PLANNING & ZONING COMMISSION

Wednesday, May 18, 2022, 10:00 AM

- B. **Request for Site Plan; Bristol Park Apartments** (Project Name); 19510 US 4541(Site Address) Limit Ave (South) US Hwy 441 (North East) (Location); Cagan Management Group, Inc. (Applicant); Wicks Engineering Services, Inc. (Engineer); L.R. Huffstetler, Inc. (Landscape Architect); Forum Architecture & Interior Design (Architect). Project No. SP22-03.

BRISTOL PARK APARTMENTS
 COVER SHEET
 MOUNT DORA, FLORIDA 34736

Sheet: 21 of 32

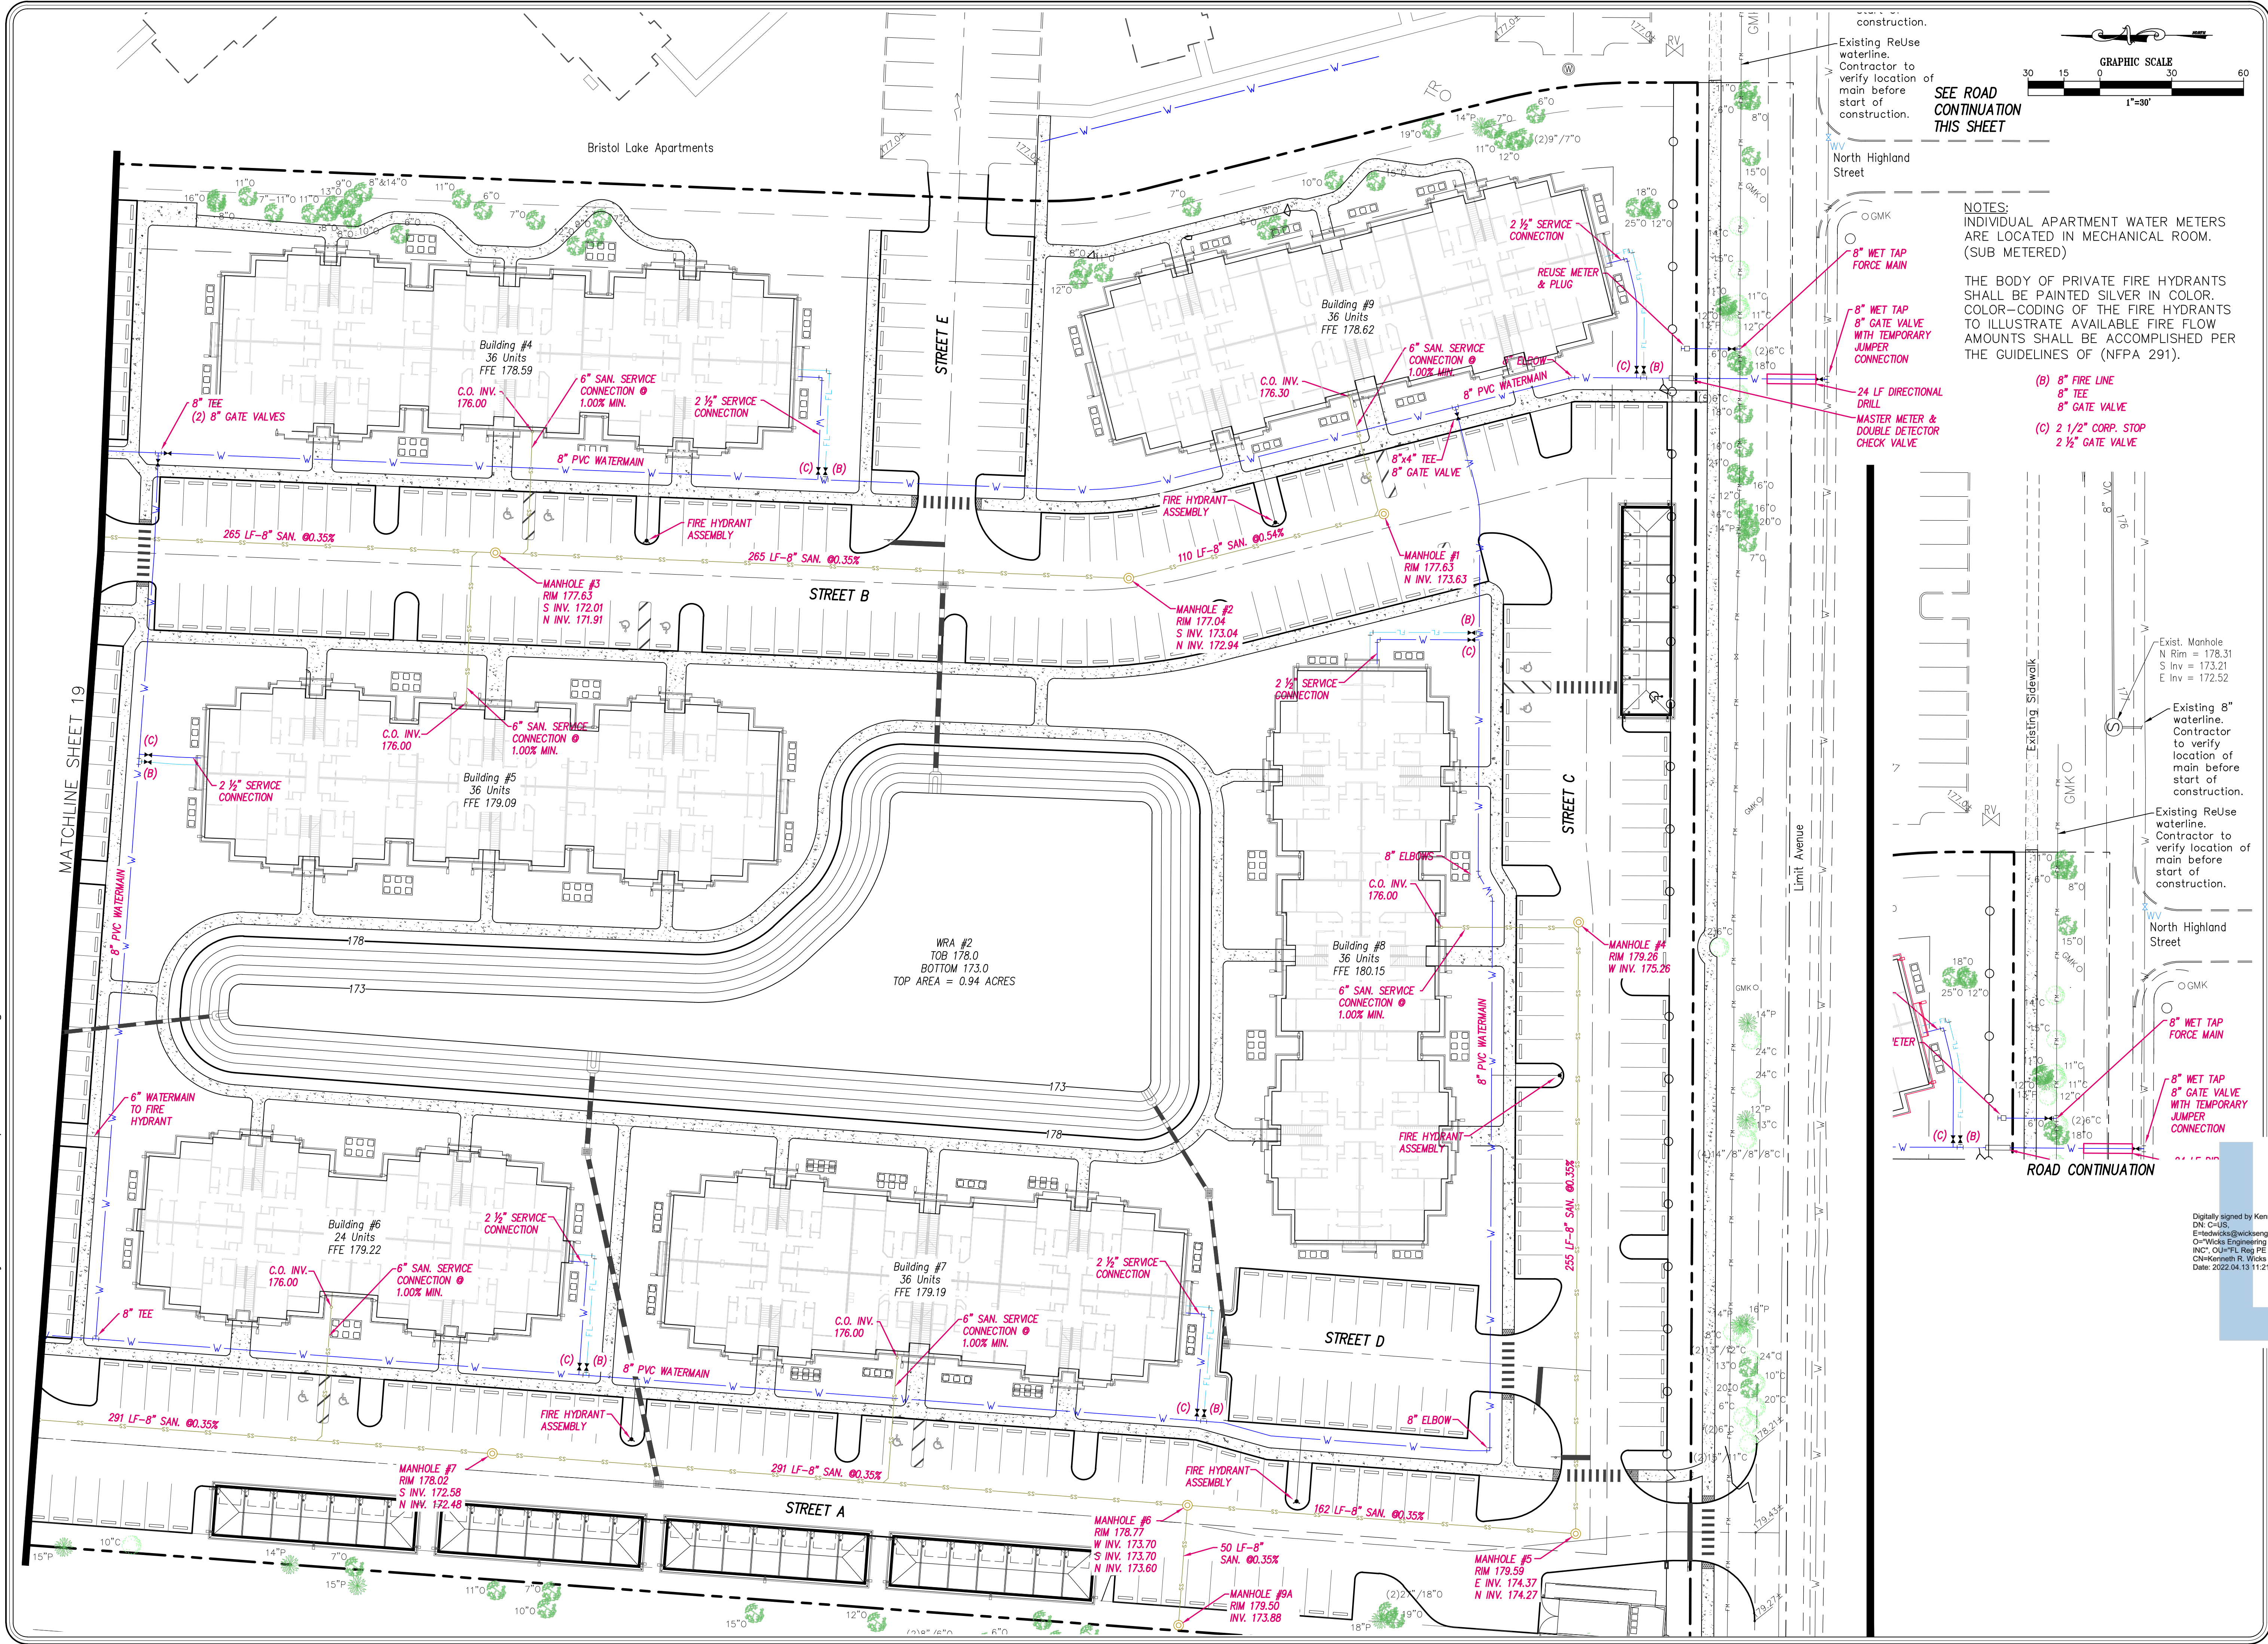
86. Sheet 21 and 22 of 32 – provide a DDCA assembly on the fire lines to each building.
87. Sheet 21 and 22 of 32 – provide an RPZ assembly on the potable line to each building.

88. Sheet 21 and 22 of 32 – provide an FDC on the fire line to each building.
89. Sheet 23 of 32 – if the elevation from the influent pipe to the slab bottom is to be 7’-6” the proposed inside bottom of the wet well can not be 168.66.

38. Plan Sheet 21/22. Note 1 in the upper right corner under the graphic scale and North arrow indicates that all individual apartment units will be submetered. Provide information on the set-up of this sub-metering as well as the provision for back-flow prevention between the services.

39. Plan Sheet 21/22. Note 1 in the upper right corner under the graphic scale and North arrow indicates that the body of all private fire hydrants shall be painted grey in color. If the utilities are proposed to be public, why is this note included with this submission? Or are the fire hydrants only proposed to be private.

Sheet: 28 of 32

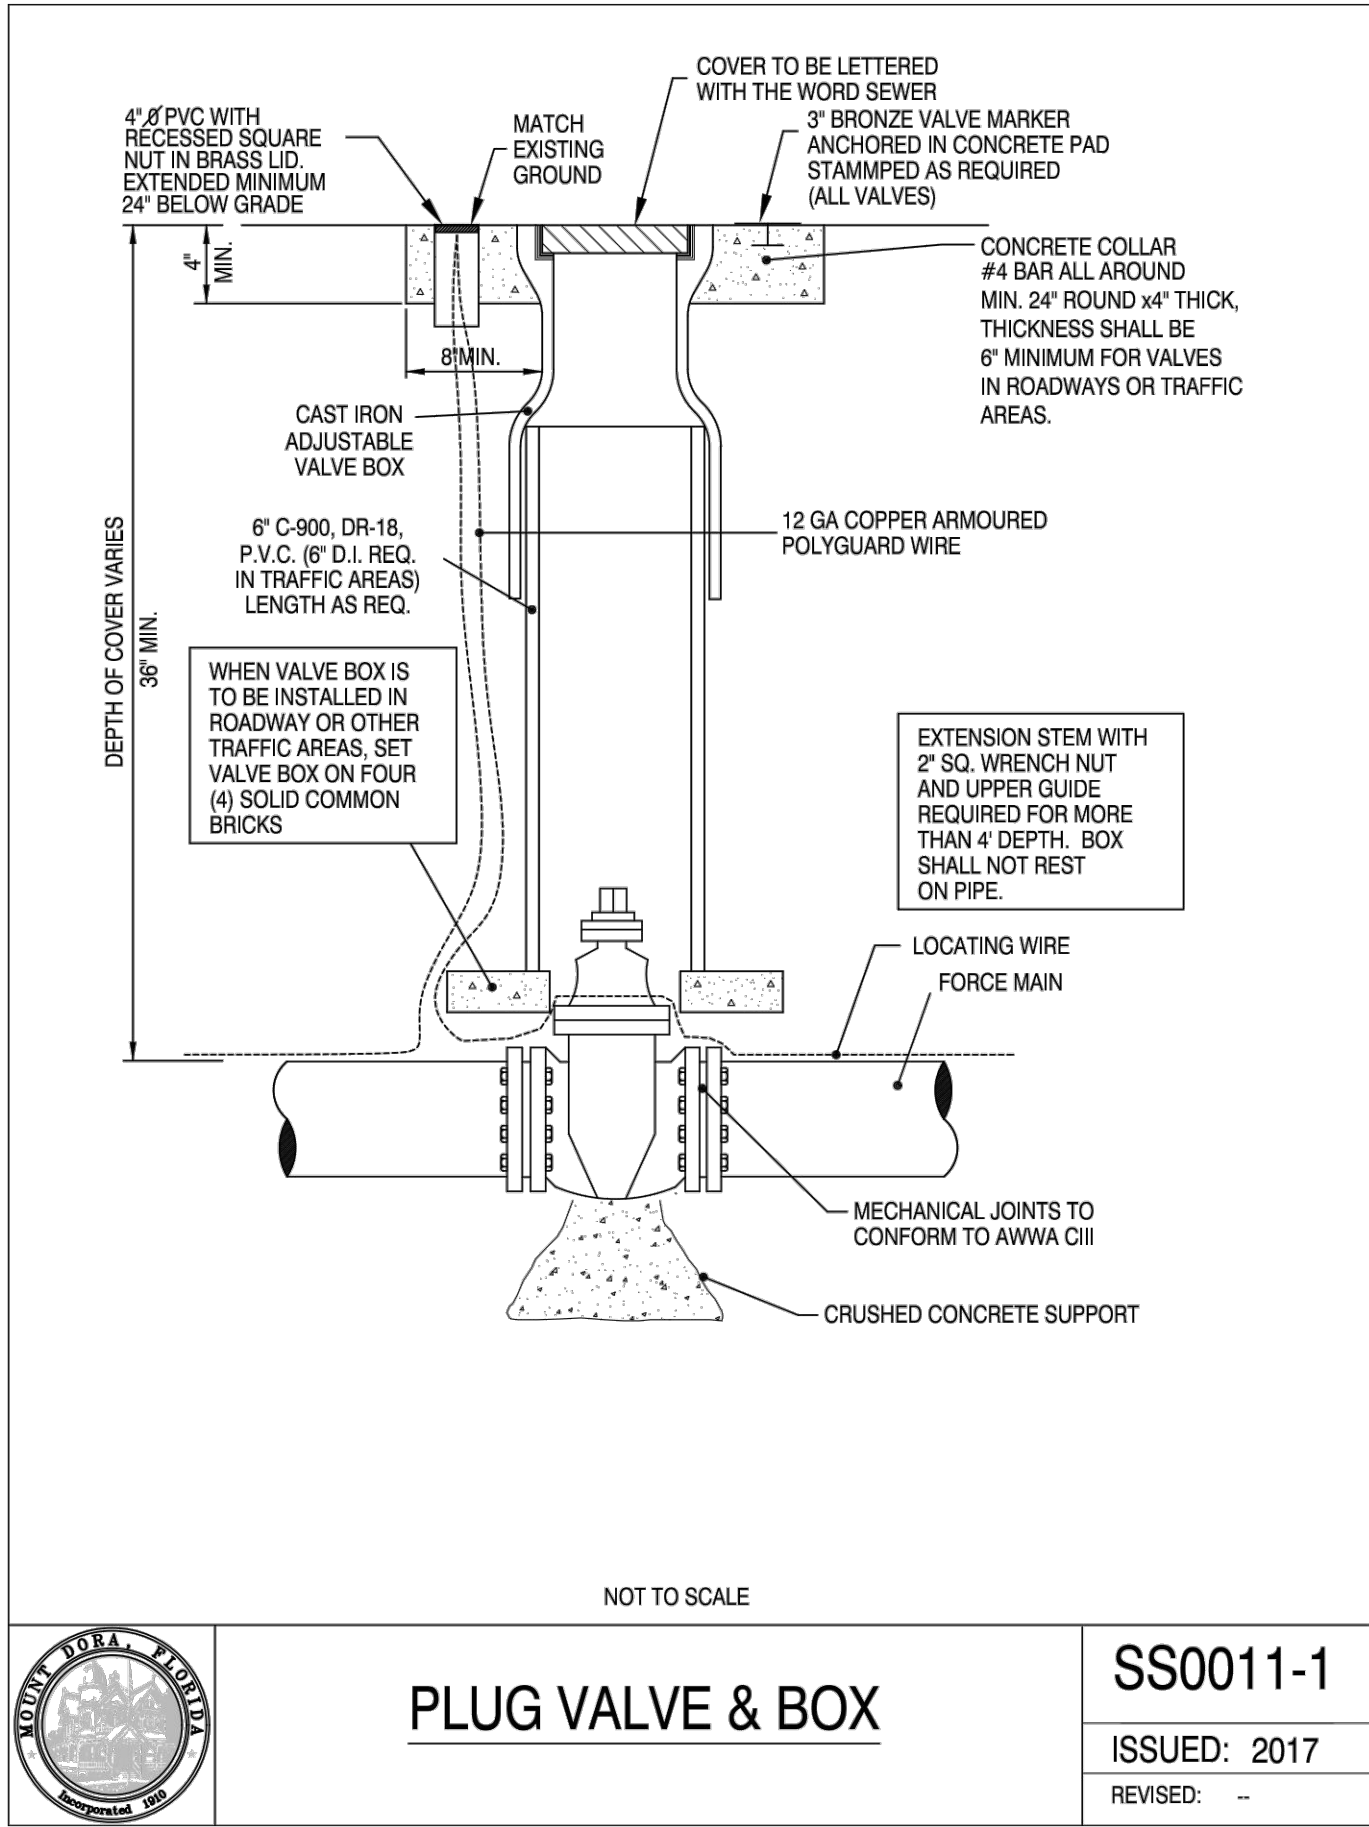
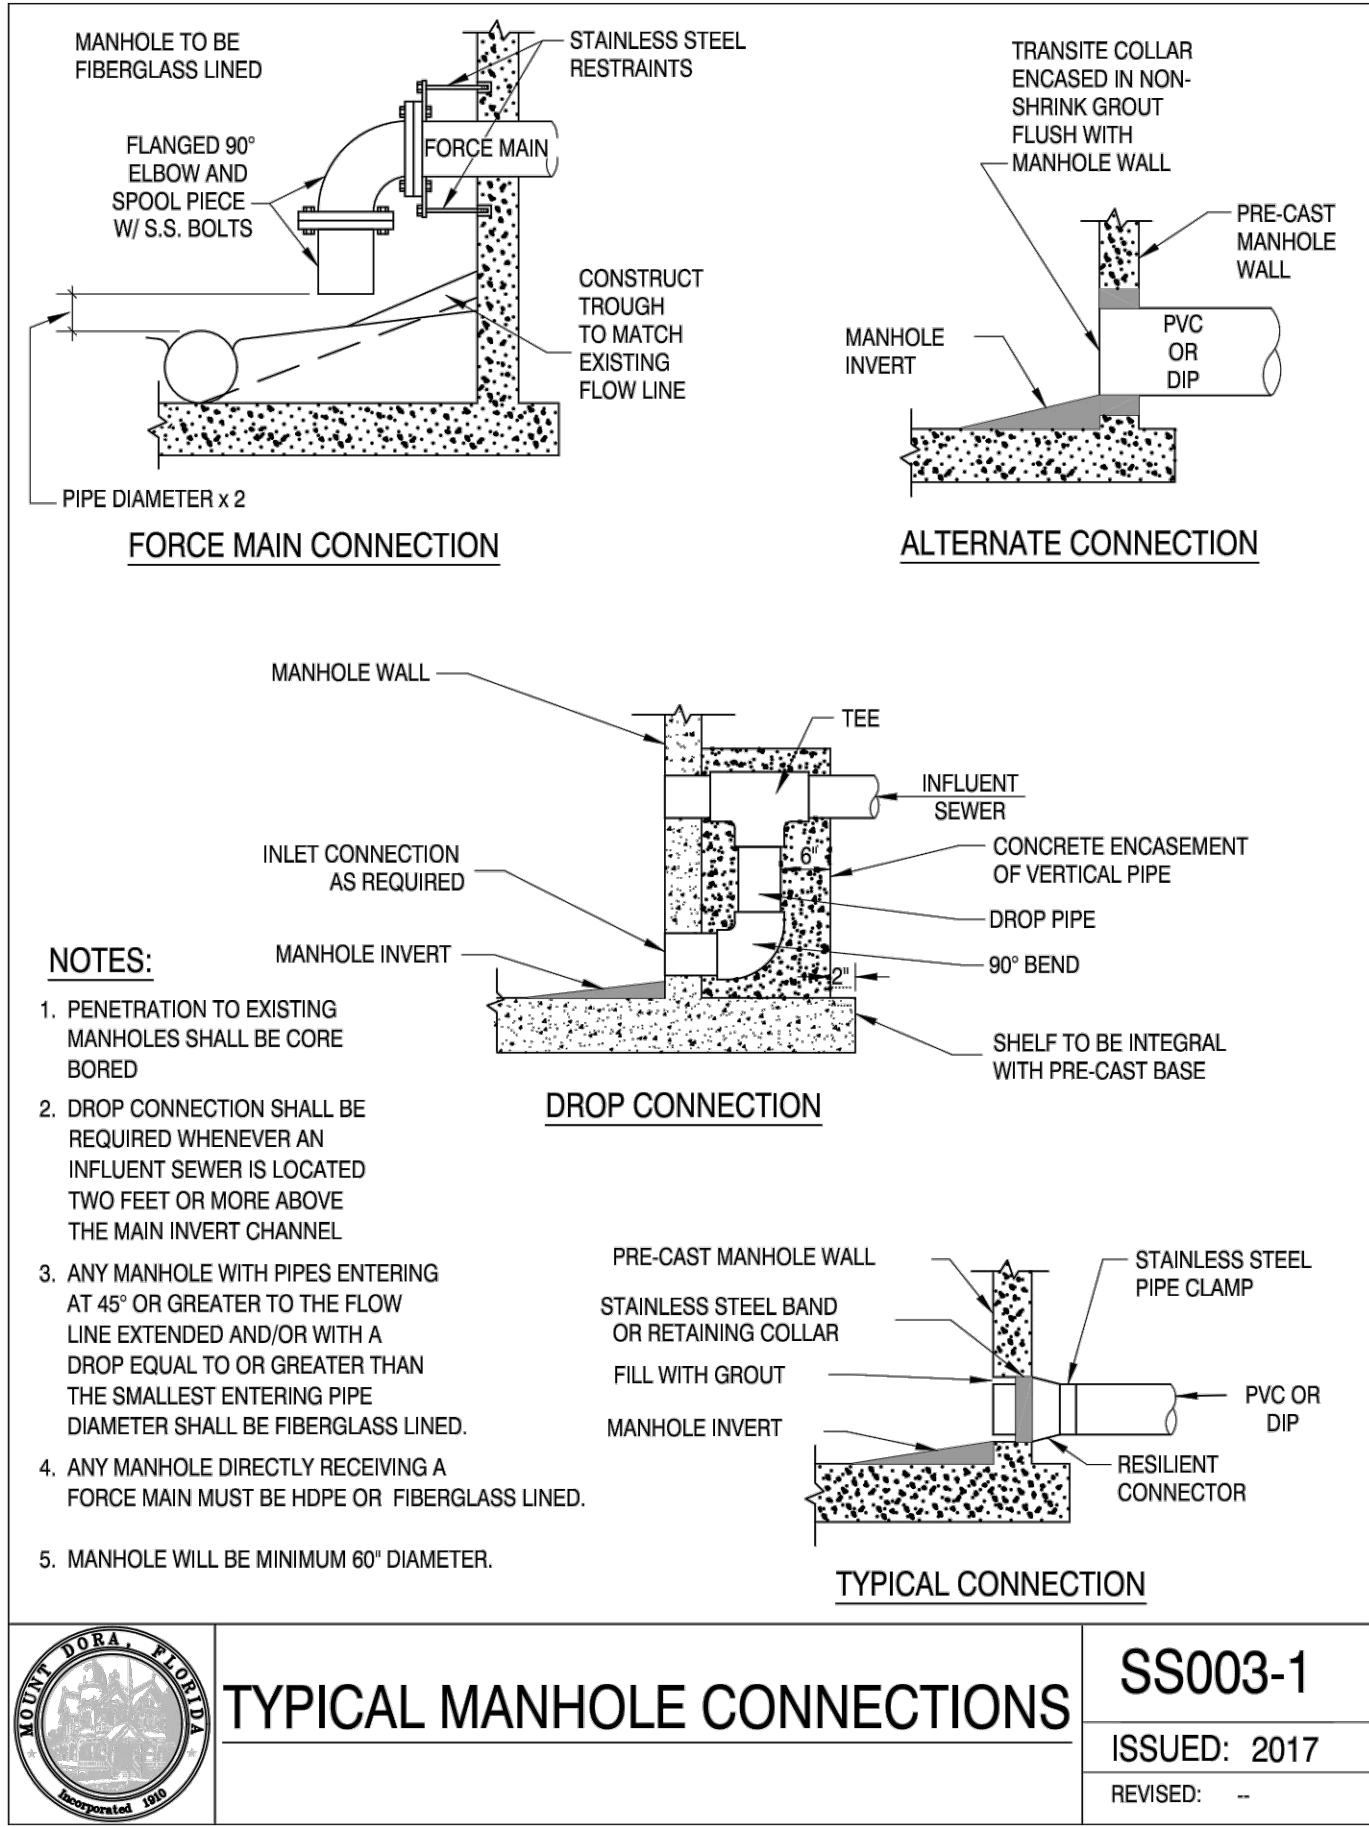
50. Sheet 22 of 26 – use the City of Mount Dora Standard Details, leave the details in their page layout. **Repeat comment – sheet 28 is not using City standard details.**
